dsPIC33EPXXX(GP/MC/MU)806/810/814 and PIC24EPXXX(GP/GU)810/814 Family Silicon Errata and Data Sheet Clarification

The dsPIC33EPXXX(GP/MC/MU)806/810/814 and PIC24EPXXX(GP/GU)810/814 family devices that you have received conform functionally to the current Device Data Sheet (DS70616G), except for the anomalies described in this document.

FIGURE 1: SIMPLIFIED BEHAVIOR

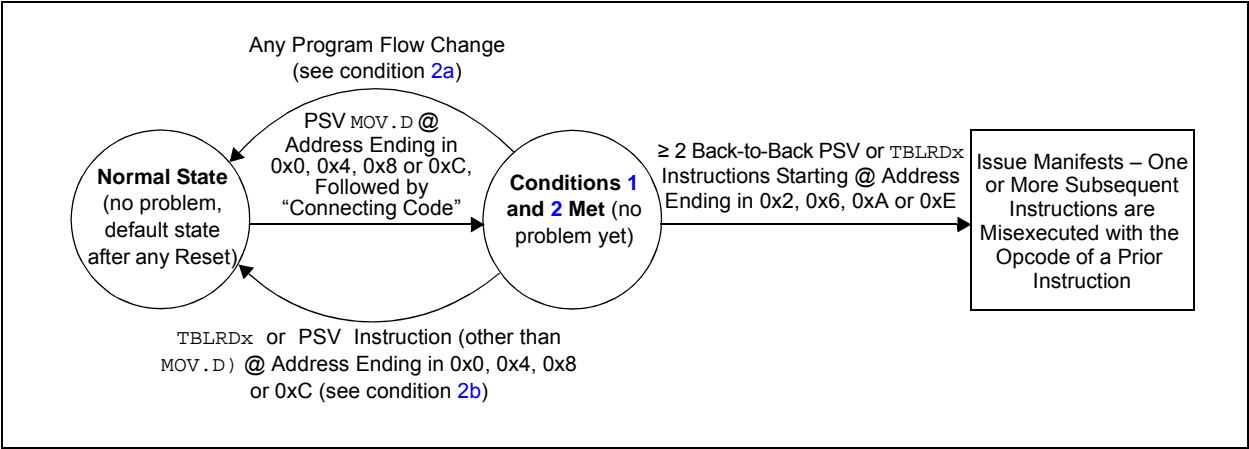
When two or more data Flash read instructions (via Program Space Visibility (PSV) read or table read) are executed back-to-back, one or more subsequent instructions can be misexecuted when all of the conditions in [Table 3](#) occur.

1.	A PSV MOV.D instruction is executed, with opcode at address ending in 0x0, 0x4, 0x8 or 0xC; and
2.	Some “connecting code” is executed (following the MOV.D of condition 1), with the properties: <ul style="list-style-type: none">a) The connecting code does not include any program flow changes, including: taken branch instructions (including all versions of BRA, CPBEQ, CPBGT, CPBLT, CPBNE), CALL, CALL.L, GOTO, GOTO.L, RCALL, RETLW, RETURN, vectoring to an ISR, returning from an interrupt (RETFIE) and certain debug operations, such as break and one-step; andb) The connecting code does not include a TBLRDx or non-MOV.D PSV instruction, located at a Flash memory address ending in 0x0, 0x4, 0x8 or 0xC; andc) The connecting code is at least two instruction words in length; andd) The connecting code does not end with a REPEAT instruction, with count > 0; and

3.	≥ 2 back-to-back PSV or TBLRDx instructions are executed (following the code of condition 2), where the first of the back-to-back instructions is located at an address ending in 0x2, 0x6, 0xA or 0xE.

[Figure 1](#) provides an example of the effective behavior.

The issue can be avoided by ensuring any one or more of the requirements are not met. For example:

1. All instances of PSV `MOV.D` can be replaced with two PSV `MOV` instructions instead. Non-PSV `MOV.D` instructions acting on RAM/SFRs do not need to be modified; or
2. If not already present, a program flow change instruction (such as `BRA $+2`) can be inserted above back-to-back data Flash read sequences; or
3. Back-to-back data Flash read instruction sequences can be broken up by inserting a non-Flash read instruction (such as a `NOP`) in between the Flash read instructions; or
4. The alignment of the code can be shifted to avoid the required opcode location addresses.

C code built with MPLAB® XC16 Compiler, Version 1.32, or later, implements the work around by default. However, if the application uses Assembly language routines, these should be manually modified to implement the work around. Additionally, if precompiled libraries are used, these should be built with XC16 Version 1.32 or later. For additional information, please visit: www.microchip.com/erratum_psrds_psrds.

FIGURE 16-2: HIGH-SPEED PWM MODULE REGISTER INTERCONNECTION DIAGRAM

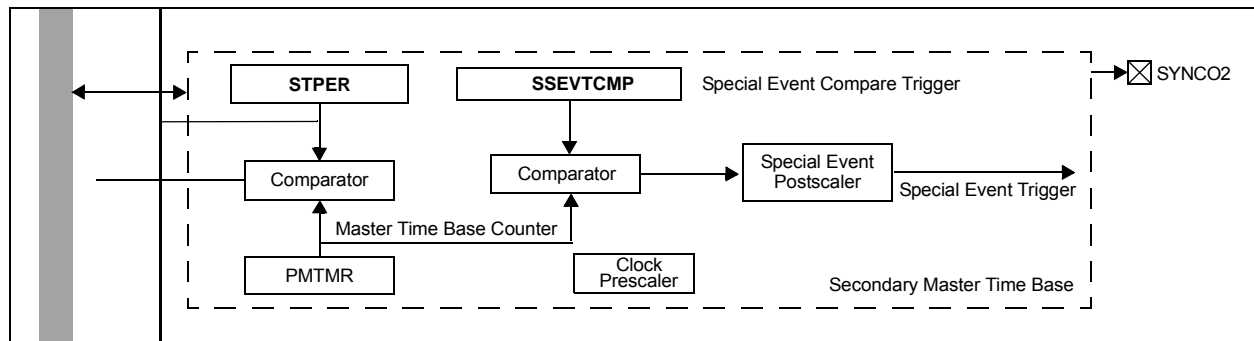
In **Figure 16-2: High-Speed PWM Module Register Interconnection Diagram**, the Secondary Master Time Base section has been updated. The updated text is shown in **bold** in [Figure 16-2](#) below.
